## Technical Memorandum

**From:** Cathy Avila, PE, Principal, Avila and Associates

**RE: Review and Update of the Draft FEMA HEC-RAS Model for the Floodplain Delineation Study of San Luis Obispo Creek, San Luis Obispo County, California**

Figure 1. Flow pattern through Highway 101 bridges.

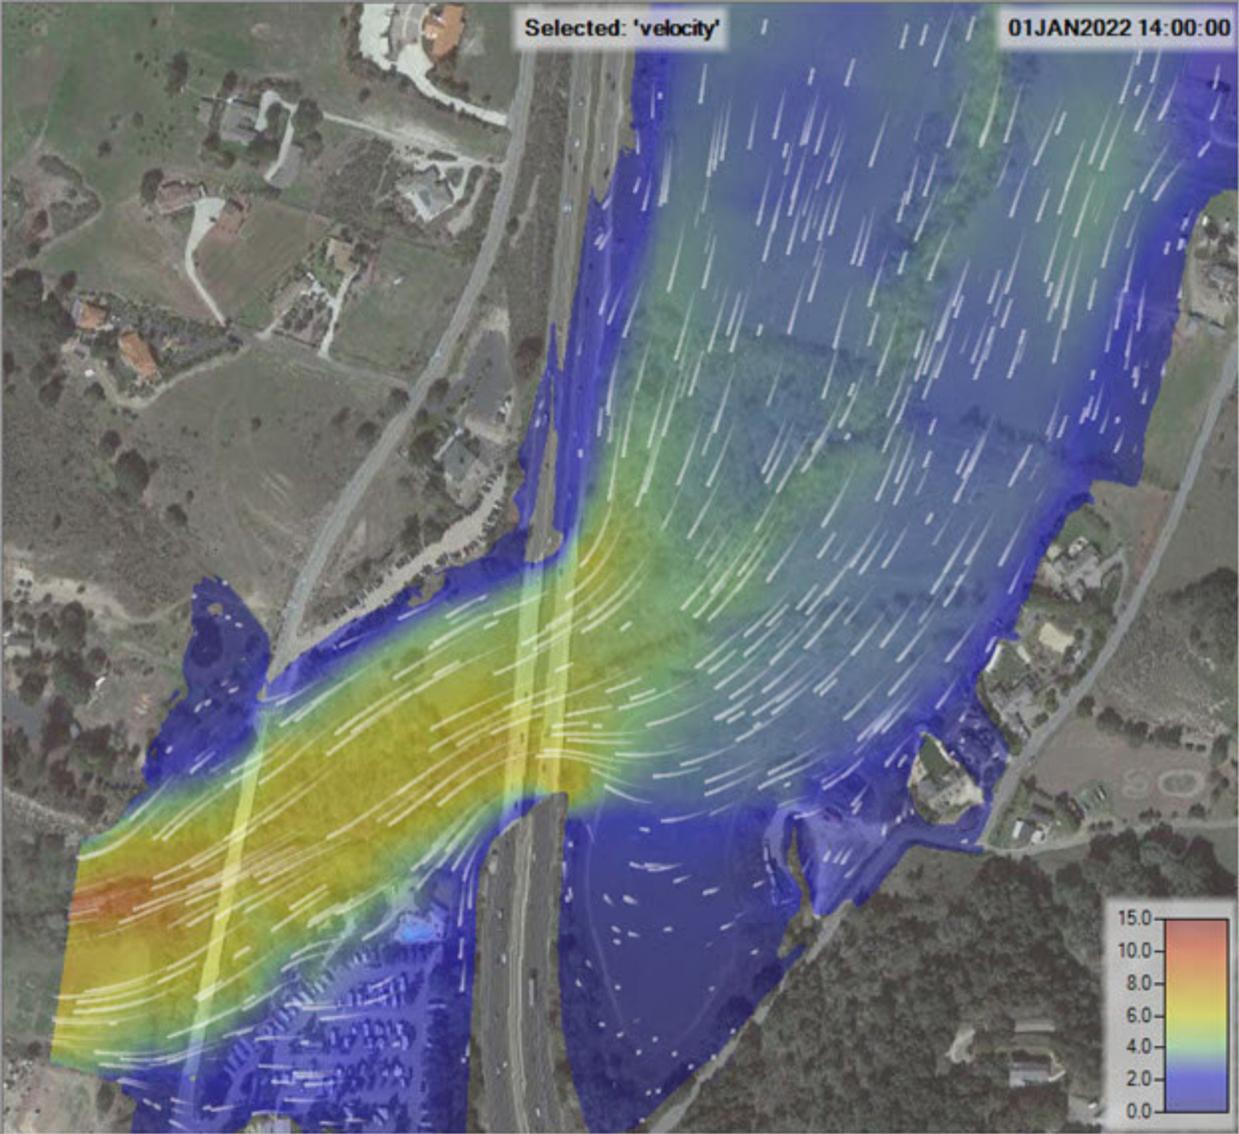
In the FEMA model, the northbound and southbound bridges were modeled as a single structure without a skew angle. A 2D hydraulic analysis of the bridge reach shows that the existing bridges are skewed approximately 30 degrees to the flow as shown in Figure 1. The following changes were made to the model geometry:

- The northbound and southbound bridges were modeled as two separate structures skewed 30 degrees. The deck, railing, and soffit elevation data was based on the WG topographic survey and match the as-built plans.
- Cross sections at river stations 14713 and 14934 were manually skewed 30 degrees and supplemented with the WG topographic survey.
- Cross sections were added at river stations 14808 and 14819 between the bridges. The sections are skewed 30 degrees and are based on the WG topographic survey.
- Internal sections for both bridges were added based on the WG topographic survey and skewed 30 degrees.

Figure 2. Comparison of the FEMA geometry (cross hatched) to the changed geometry (shaded gray) of the upstream face of the northbound Highway 101 bridge.

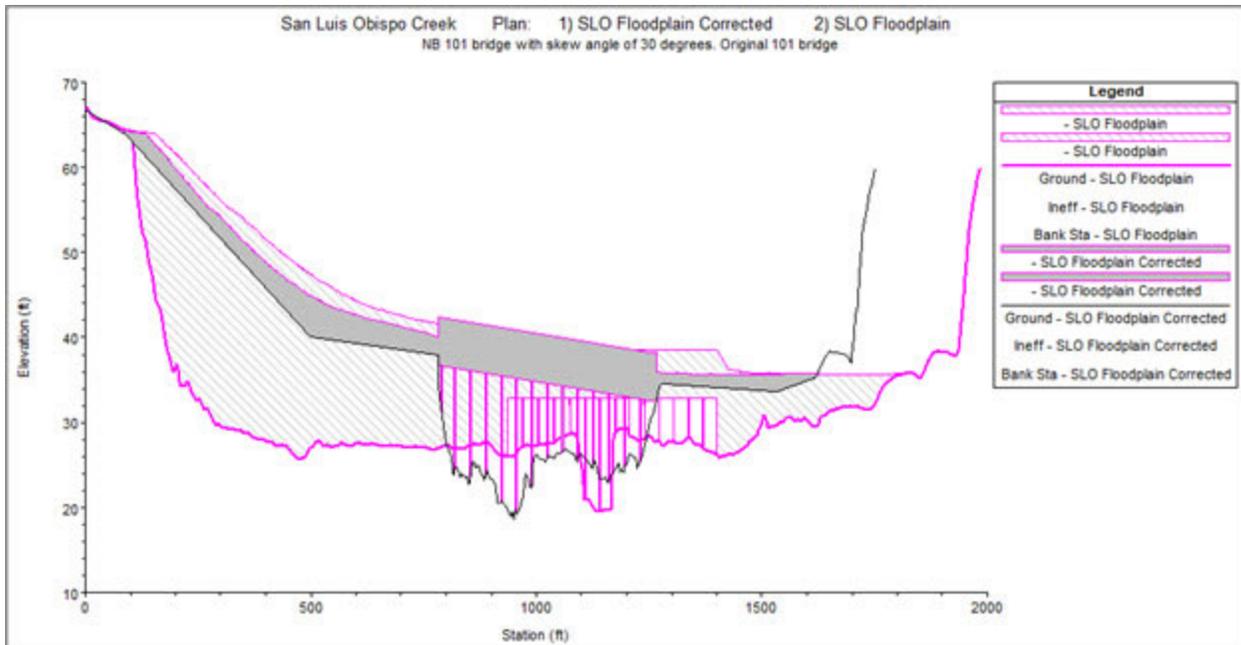
A comparison of the upstream face of the northbound bridge (RS 14848) between the FEMA model and the changes made based on the skew angle and the WG topographic survey is shown in Figure 2.

Figure 3. Comparison of the FEMA geometry (cross hatched) to the changed geometry (shaded gray) for the Bunnell Bridge (RS 29399)

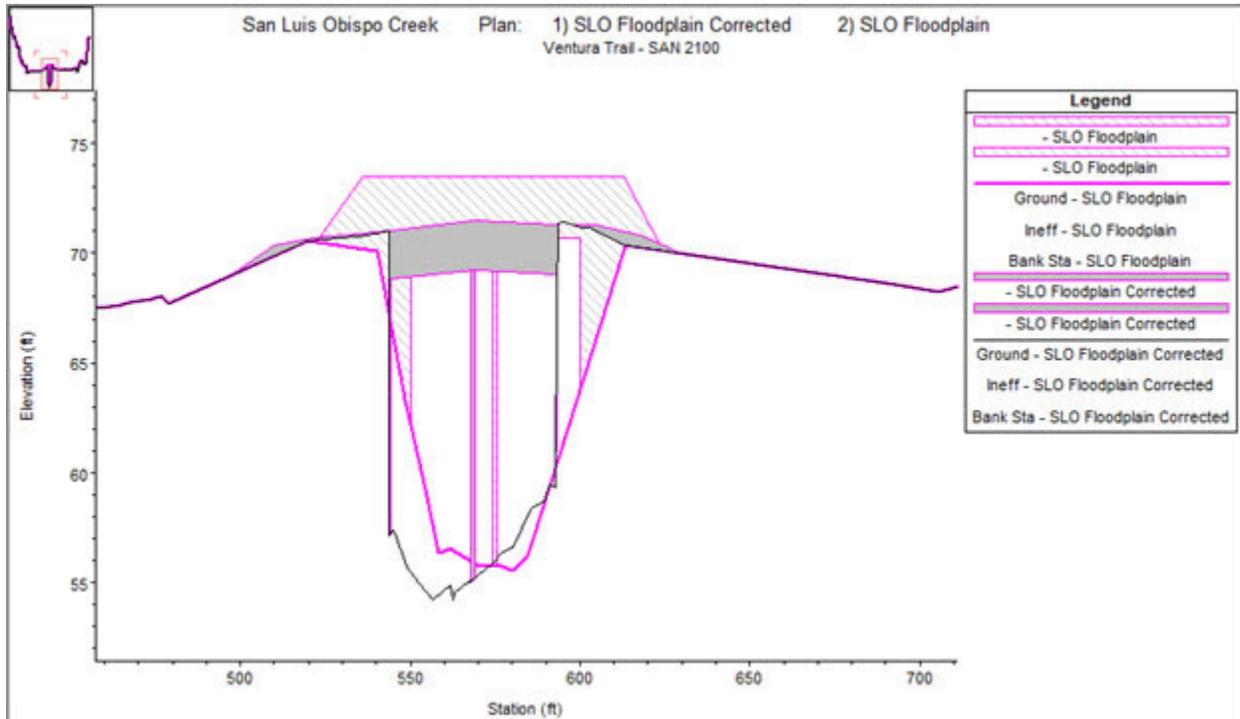
The existing Bunnell bridge was revised to incorporate the WG topographic survey. Internal sections were also added based on the WG topographic survey. A comparison of the FEMA geometry to the changed geometry of the upstream bridge face is shown in Figure 3.

Figure 5. Higuera Street Bridge with terrain and FEMA model cross sections

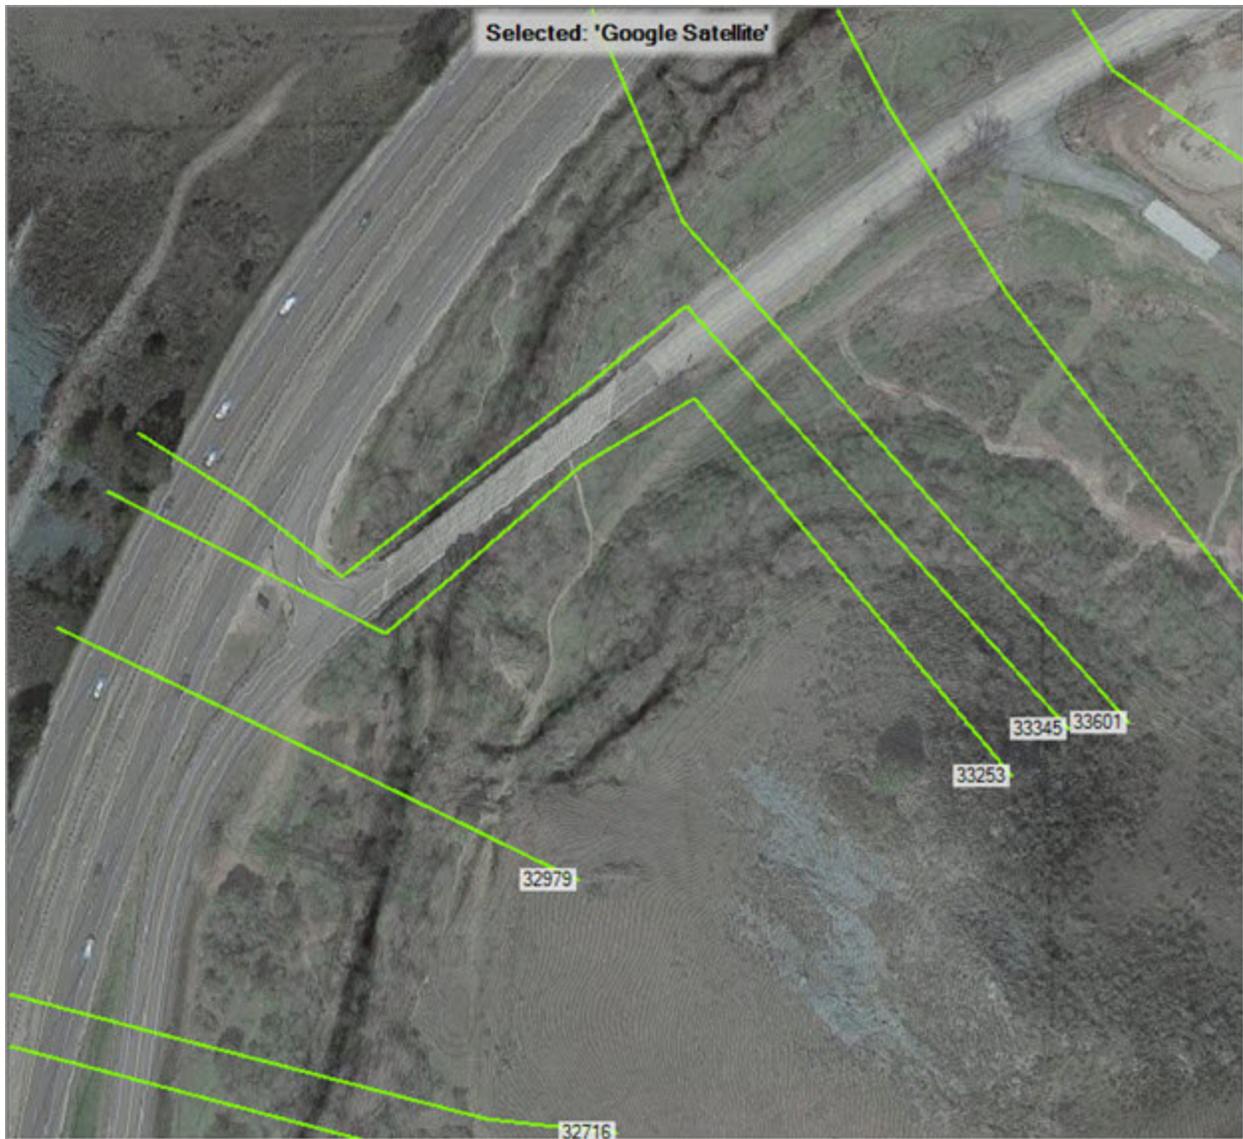
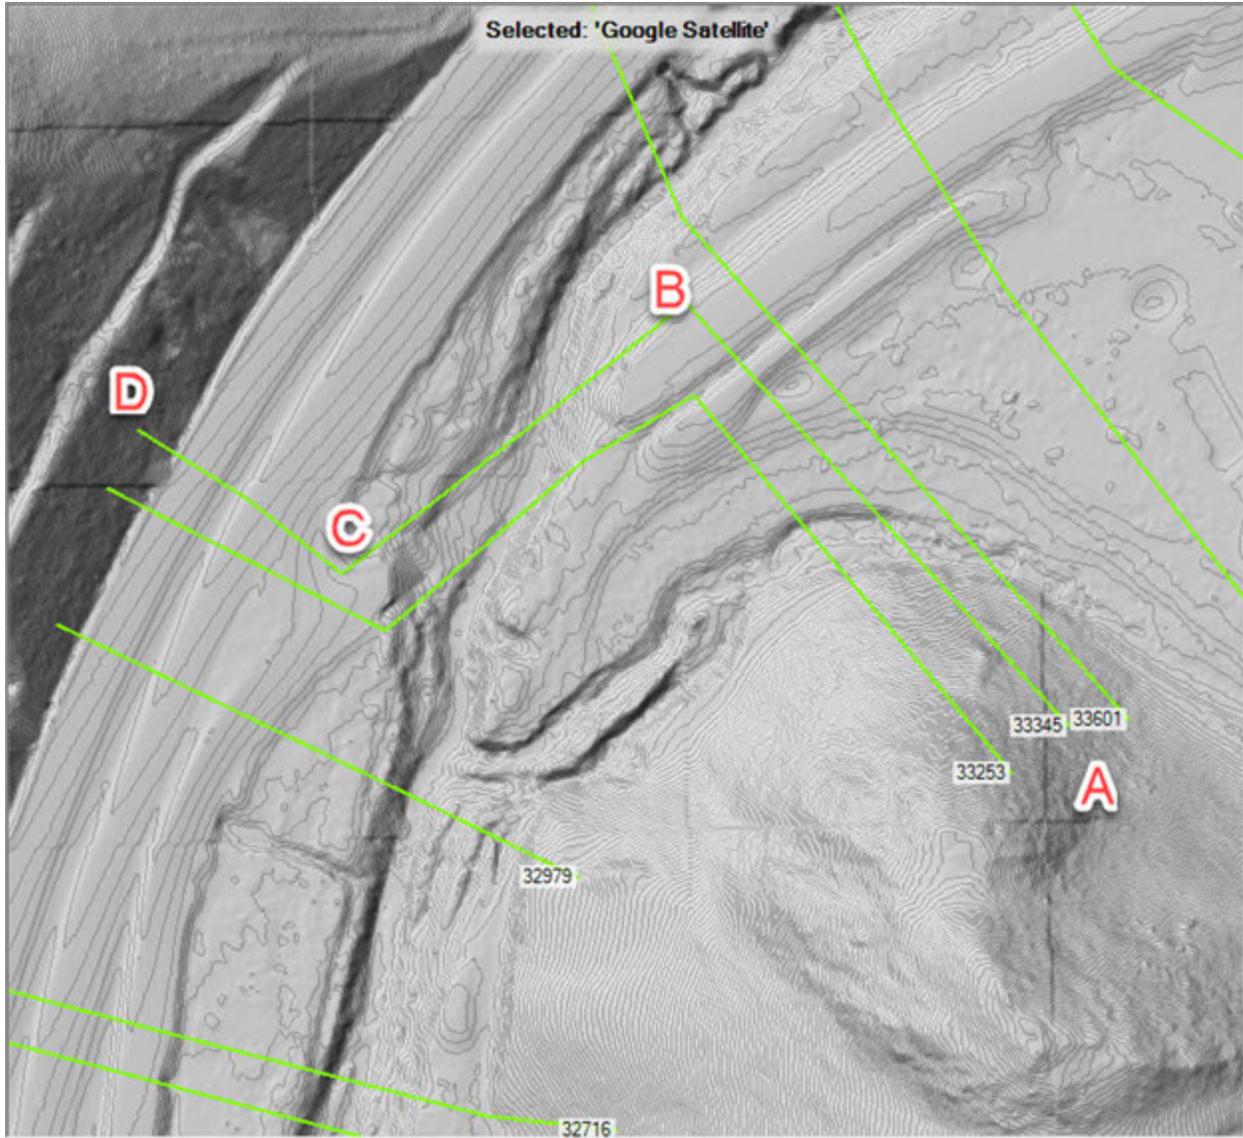
The Higuera Street bridge along with the bounding cross sections in the FEMA geometry are shown in Figure 4 and Figure 5. The bridge is skewed 45 degrees to the channel. For both cross sections RS 33345 and RS 33253, the skew angle option is used in the cross section geometry with an angle of 45 degrees. However, when the “Plot Terrain” option is used in the section geometry editor window, the cross section data matches the terrain. This indicates that the section data is not skewed. RS 33345 and RS 33253 were changed as follows:

- Cross section data for Segment A-B (as shown in Figure 5) was maintained without a skew angle.
- Cross section data for Segment B-C was skewed with an angle of 45 degrees and updated to reflect the WG topographic survey.
- Cross section data for Segment C-D was maintained without a skew angle.

Figure 6. Comparison of RS 33345 cross section data between FEMA (magenta) and changed (black) with segment between B-C skewed 45 degrees

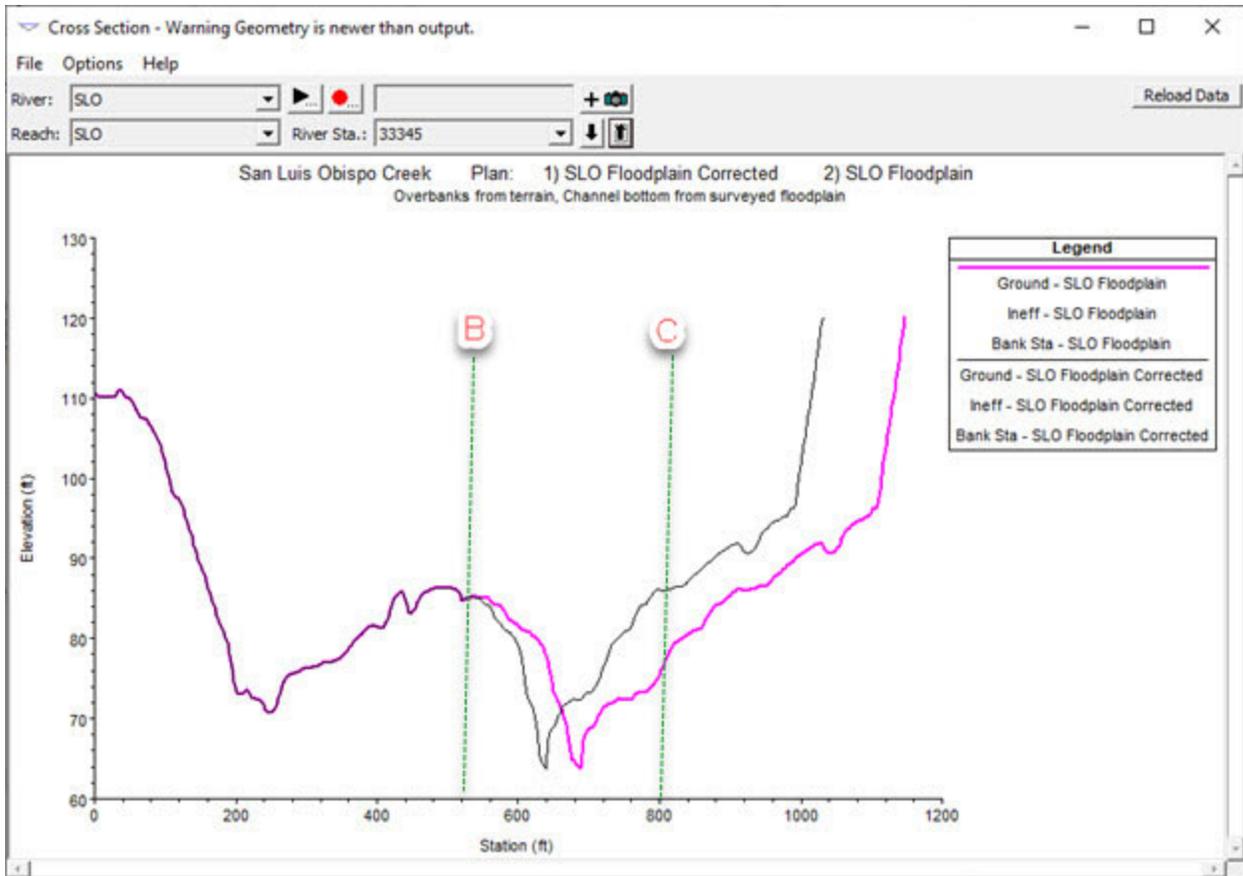
The resulting cross section data for the two river stations compared to the FEMA geometry is shown in Figure 6 and Figure 7.

Figure 8. Comparison of the FEMA geometry to the changed geometry for the Higuera Street Bridge (RS 33278)

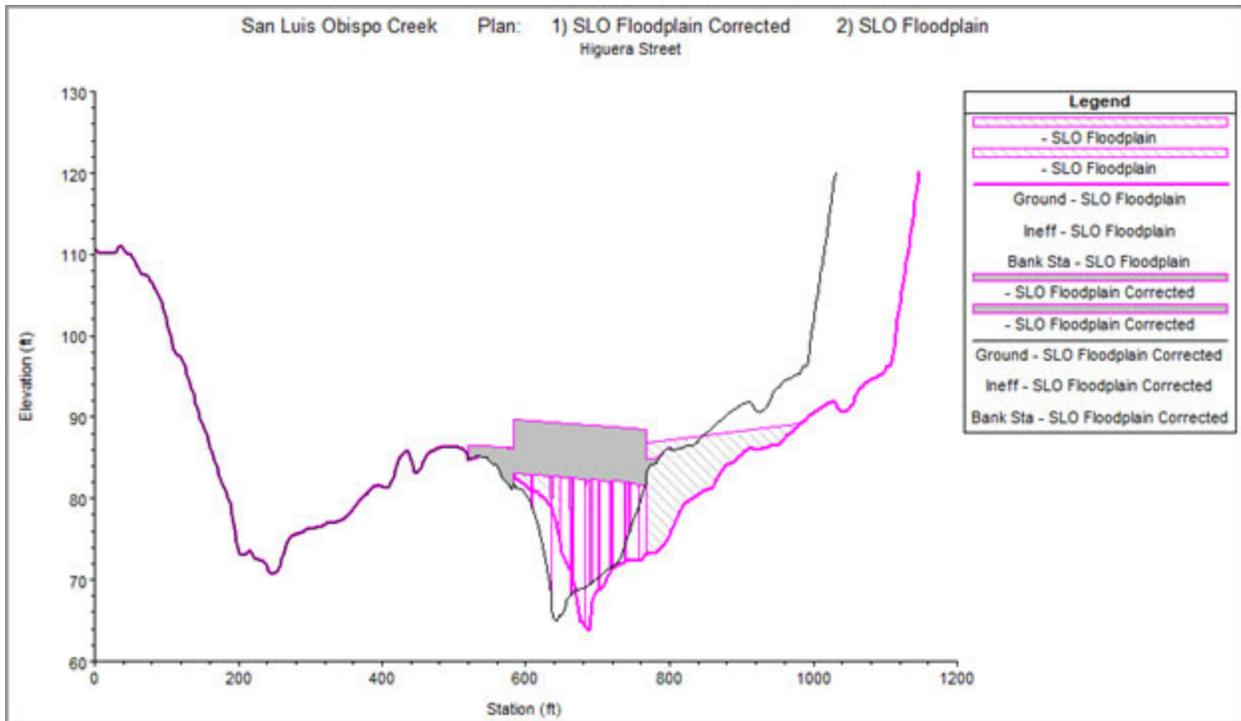
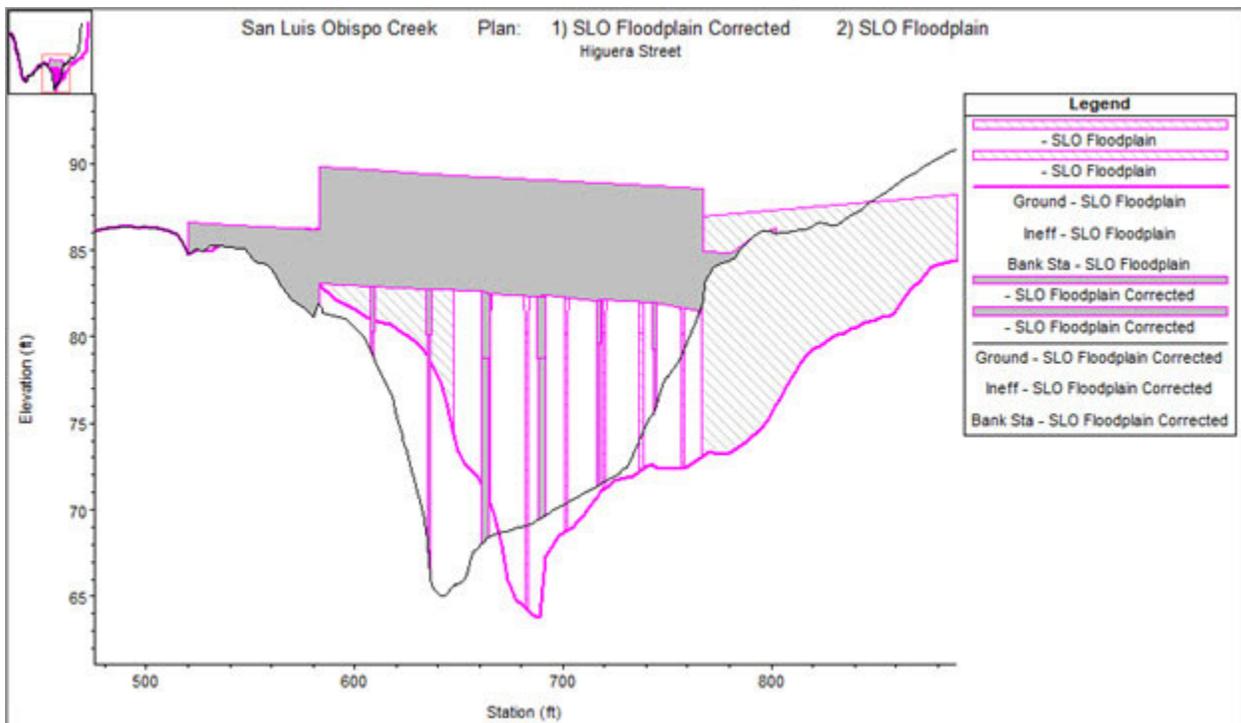
- The deck, railing, and soffit elevation data was based on the WG topographic survey and skewed 45 degrees.
- Internal sections were defined based on the WG topographic survey and skewed 45 degrees.

A comparison of the upstream face of the Higuera Street bridge (RS 33278) between the FEMA model and the changes made based on the skew angle and the WG topographic survey is shown in Figure 8 and Figure 9.

Based on the WG topographic survey, the effective hydraulic opening of the bridge (distance between abutments normal to the direction of flow) is approximately 185 feet. The effective hydraulic opening in the FEMA bridge geometry is approximately 119 feet. This difference can be seen in Figure 9. To illustrate what a hydraulic opening of 119 feet would look like in plan view, it has been added to Figure 10 which shows the surveyed abutments and hydraulic opening of 185 feet. Note that the 119 feet dimension is not the location of the opening in the FEMA model and is for illustrative purposes only. The skew angle option for the bridge deck data in the FEMA geometry is not used.
